SERVICE BULLETIN

APPLICABILITY: 2017-18MY Impreza
2018MY Crosstrek

NUMBER: 07-123-17

SUBJECT: DTC B1661 / B1502, Change to Warning Box Assembly

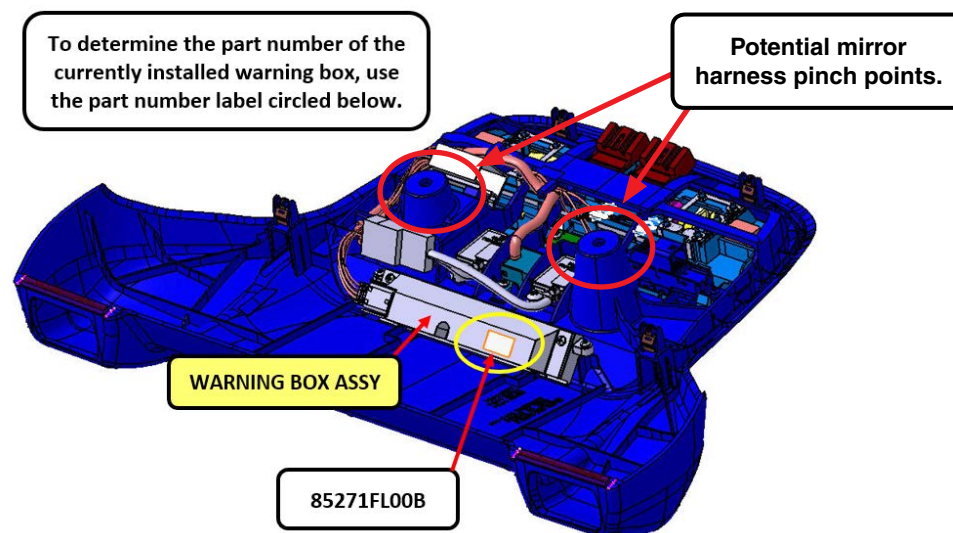
A design improvement has been made to the warning box assembly for improved responsiveness. The warning box is located inside the overhead map light assembly as shown in the illustrations below. The warning box part number has also been changed.

NOTE: This change also affects EyeSight camera covers (COVER ASSY ST CMR) and map lamps (LAMP ASSY MAP STD) because the warning box is included as part of these assemblies. Aside from the warning box improvement, there are no other changes to these two parts.

The part number for the new warning box assembly is **85271FL00B**.
